APPROVED
Limited building only review
Permit holder responsible for full compliance with the code

289 BRET ROAD RESIDENCE
CAMERON, HARNETT COUNTY, NORTH CAROLINA

SHEET TITLE:
ELEVATIONS / BUILDING DATA

SHEET TITLE:
ELECTRICAL PLAN

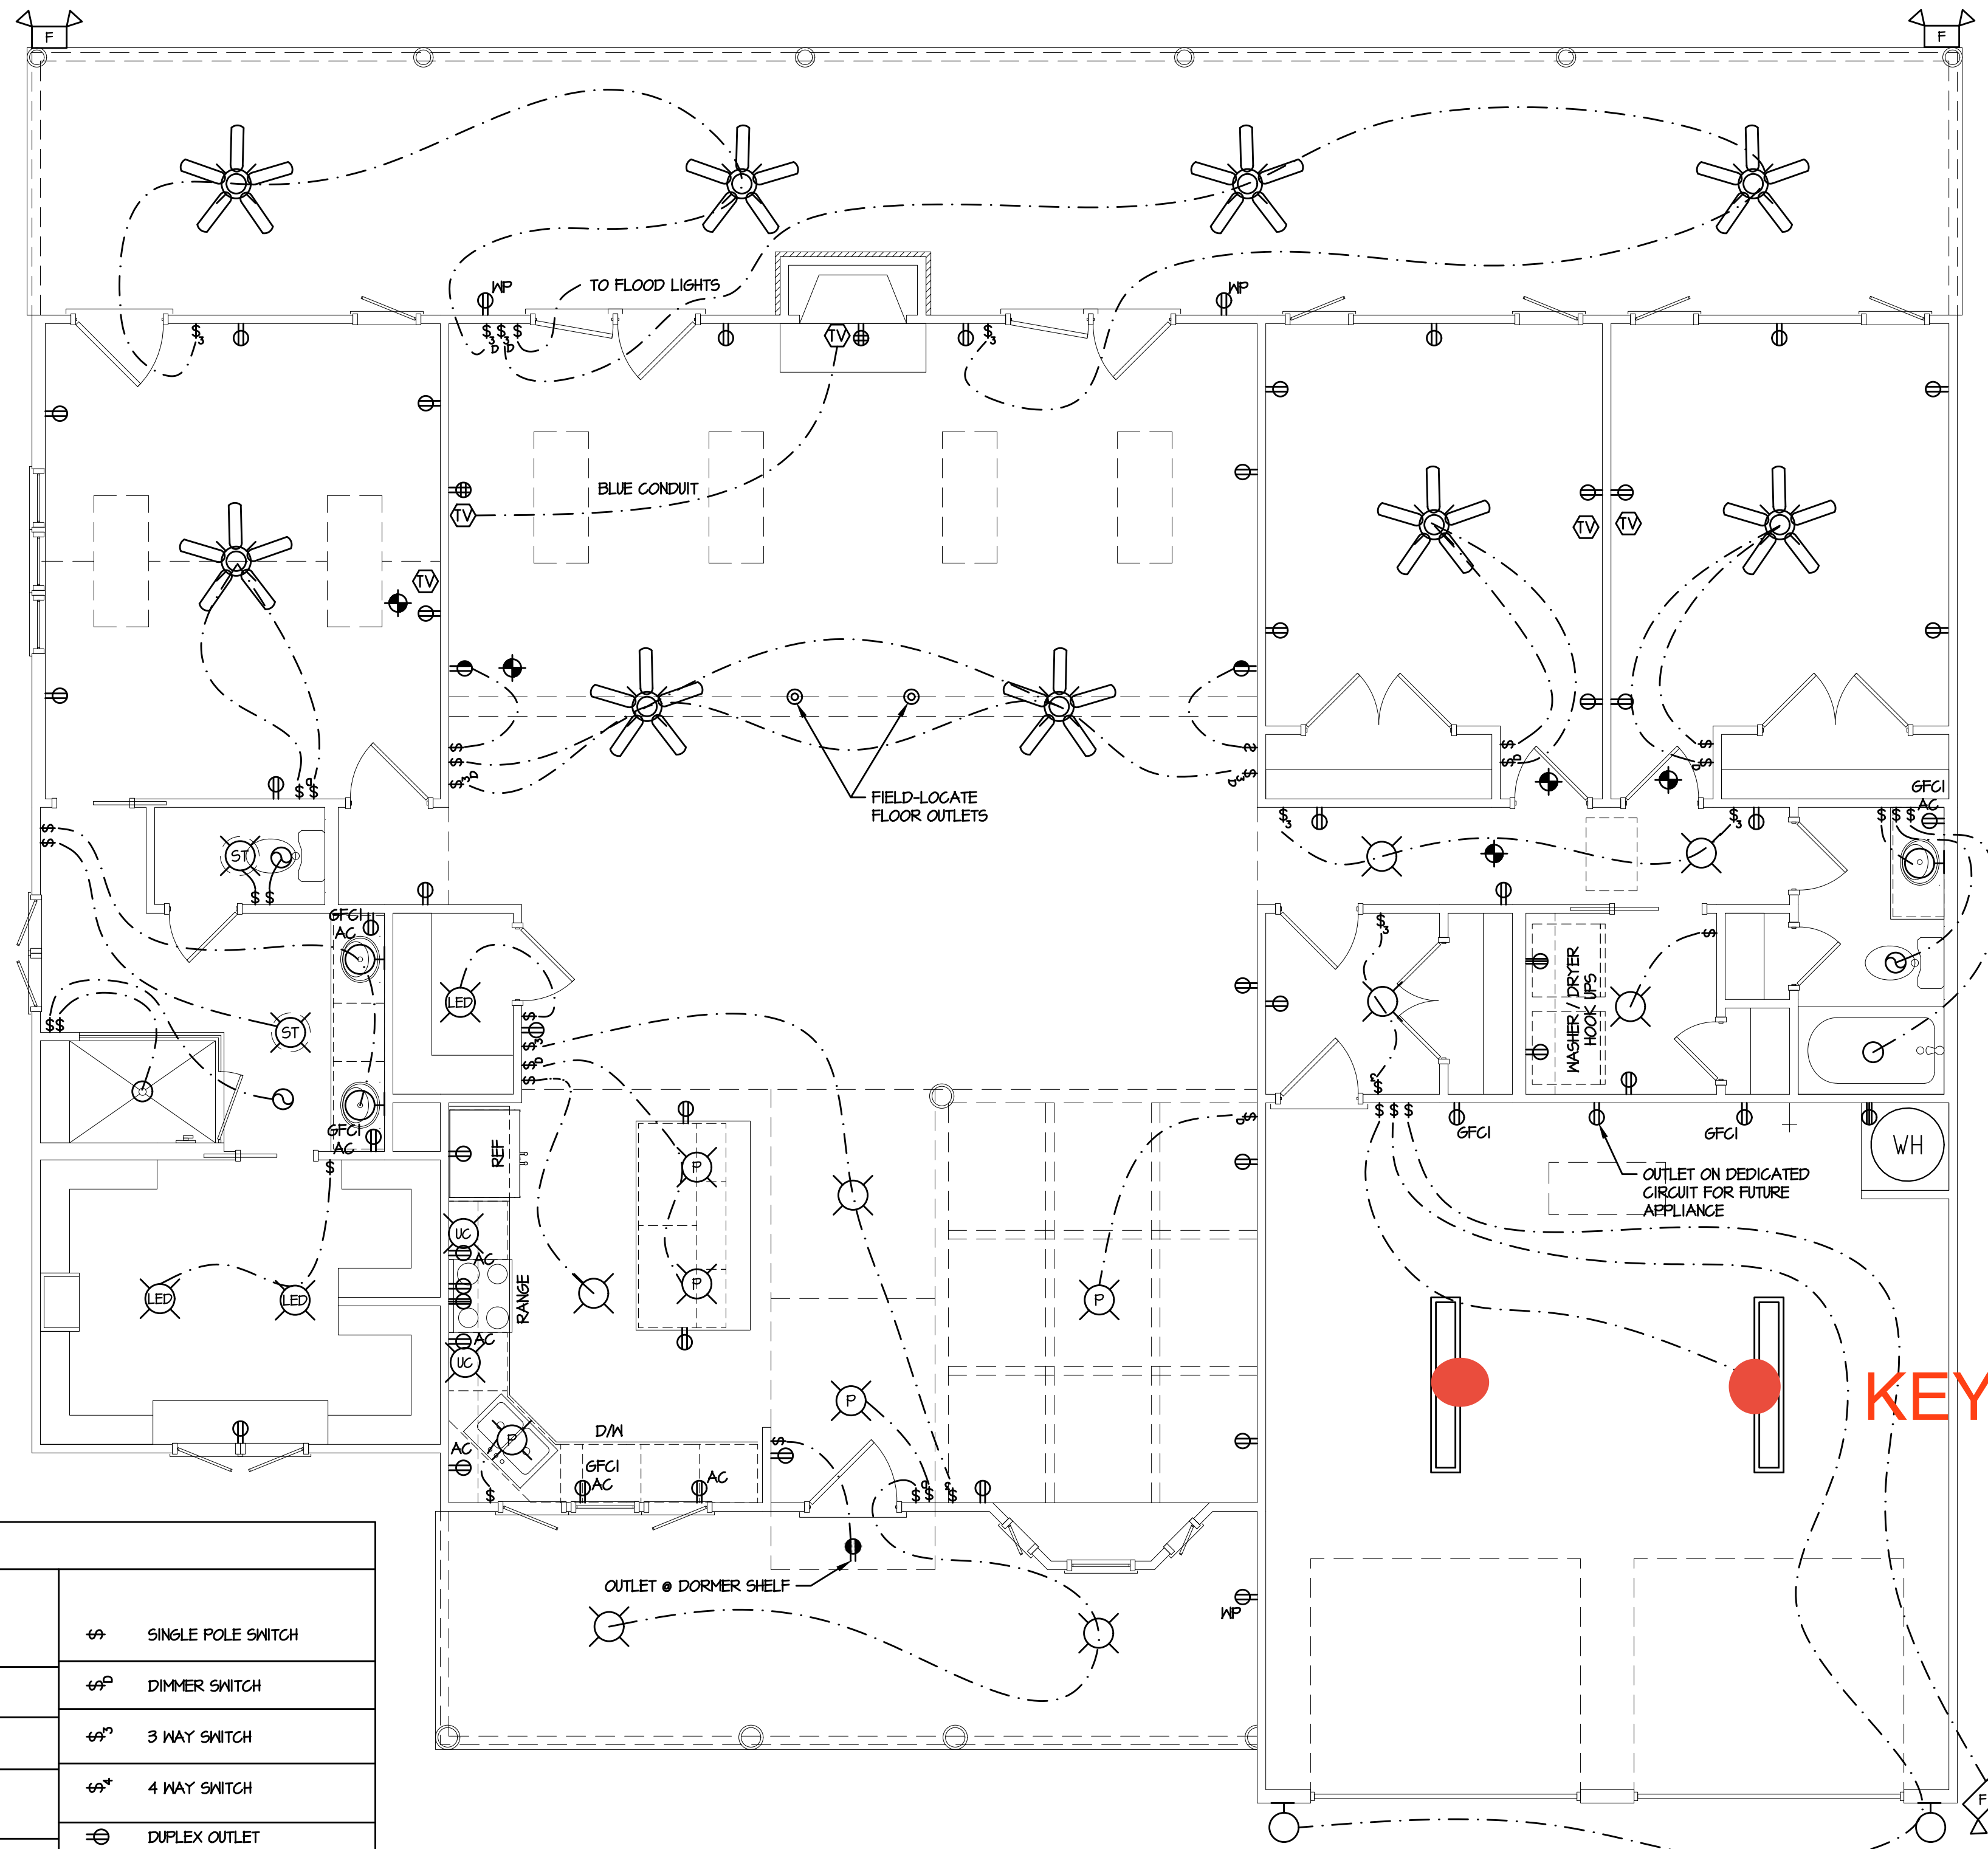
Ceiling receptacles for 8 foot tall garage doors

(C) TYPICAL WALL SECTION
3/4" = 1'-0"

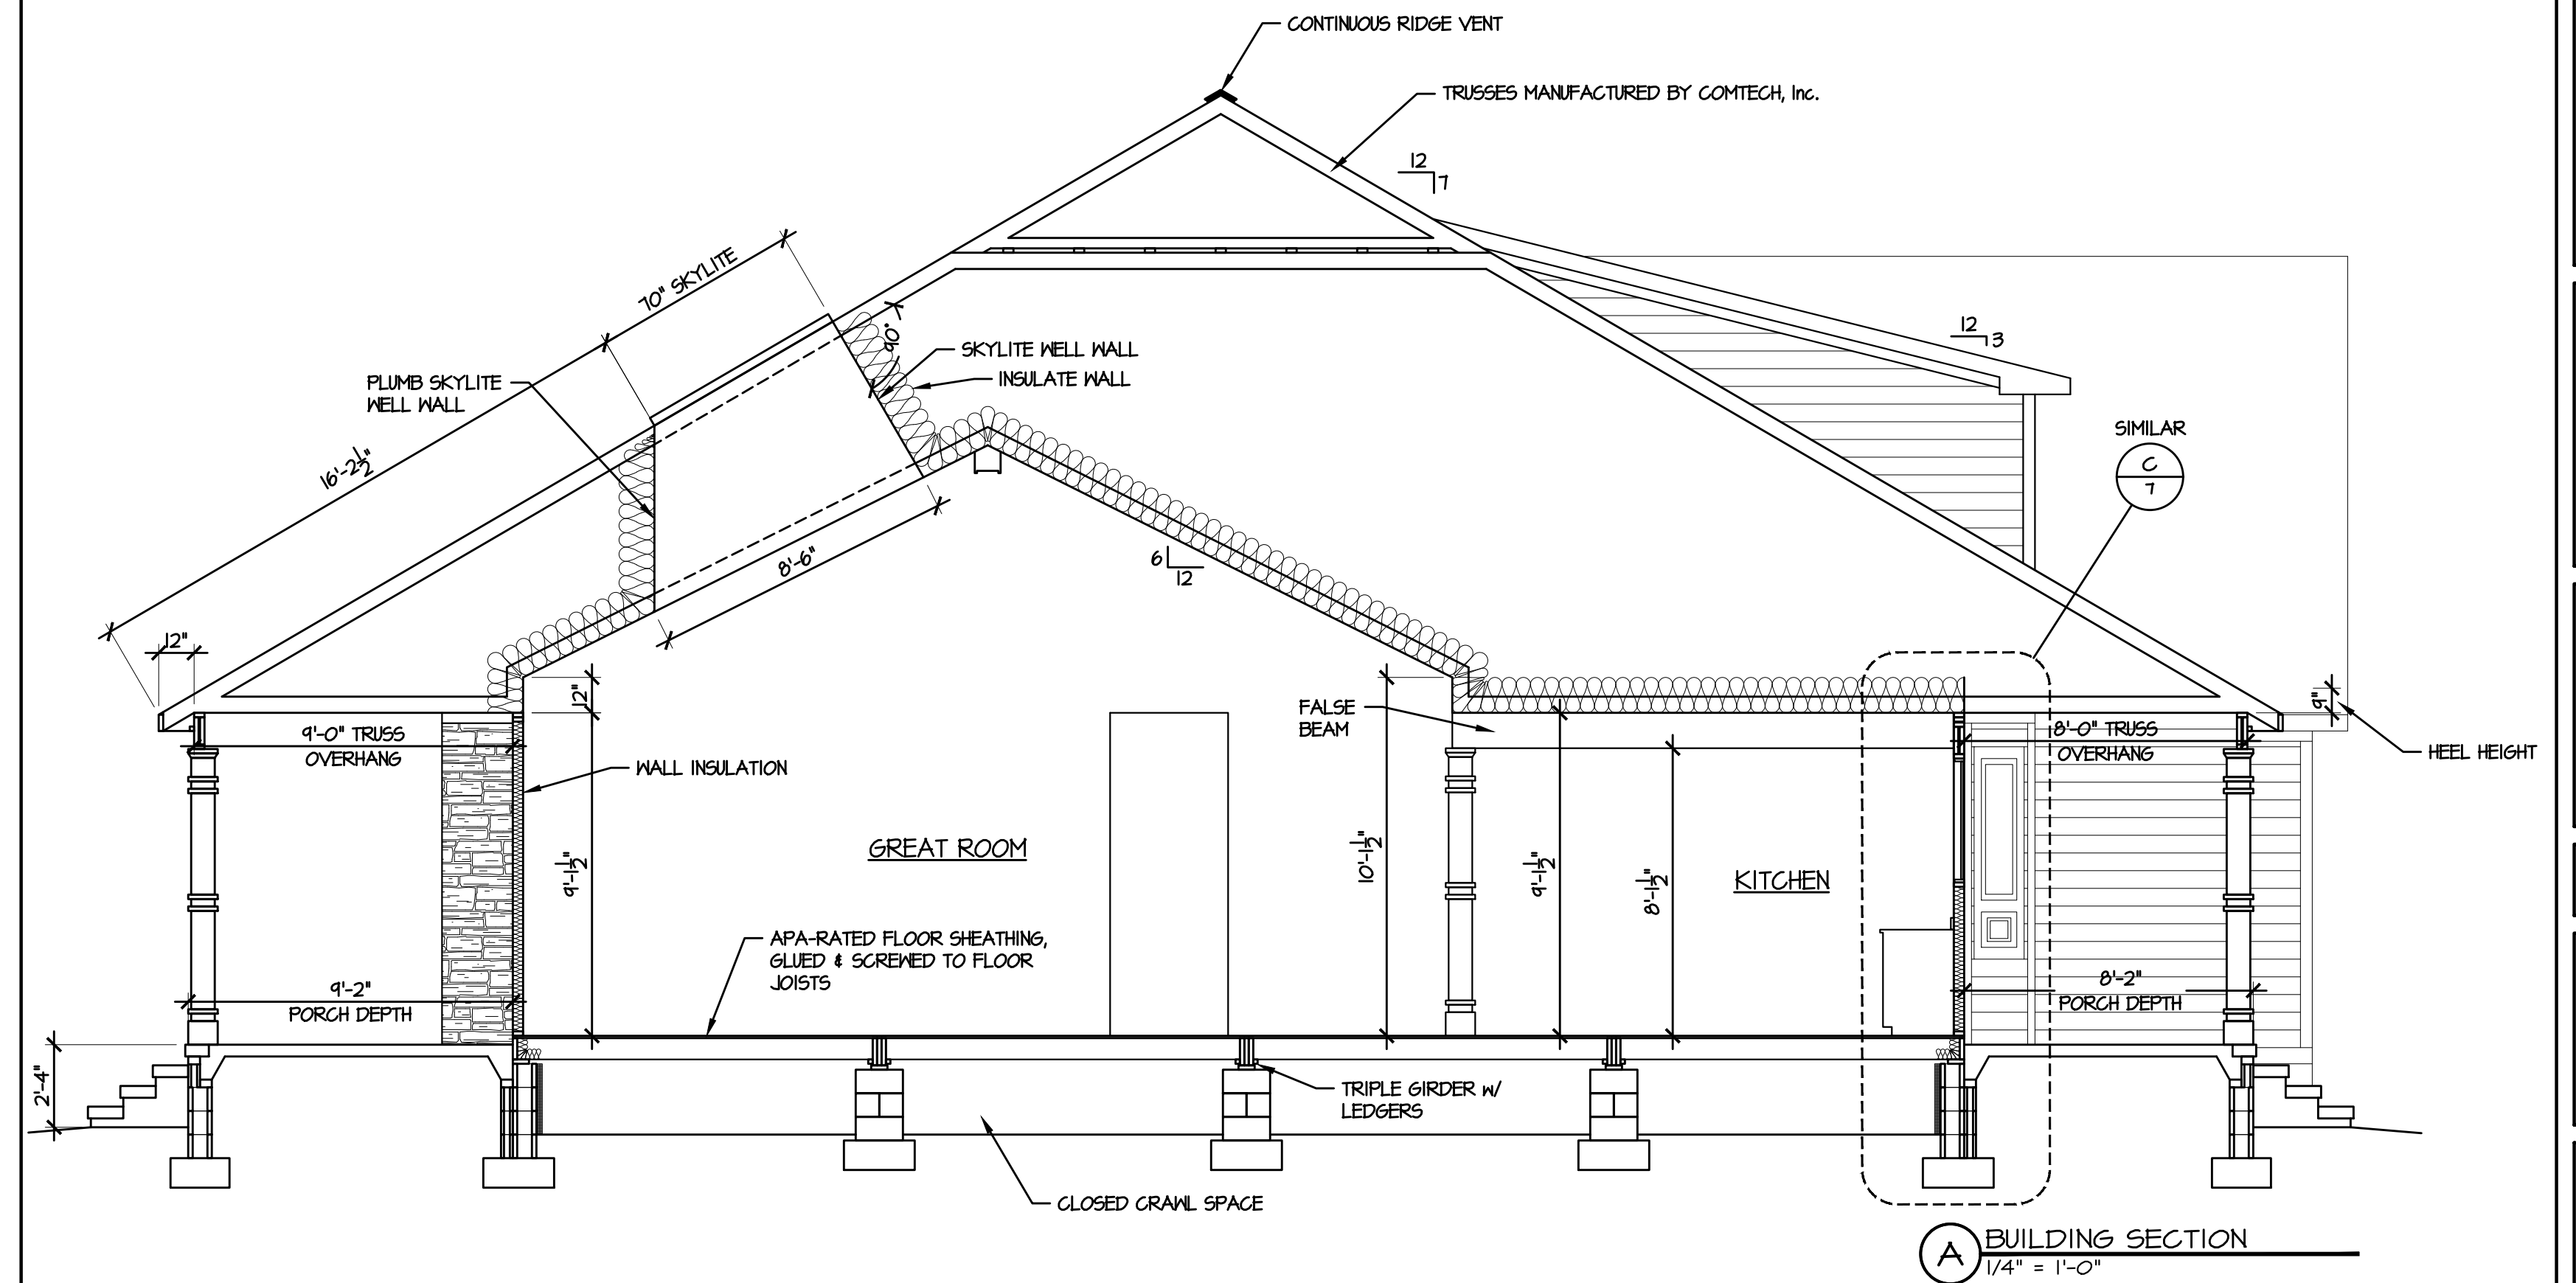
4 and 8 brick and block foundation wall. See attachment.
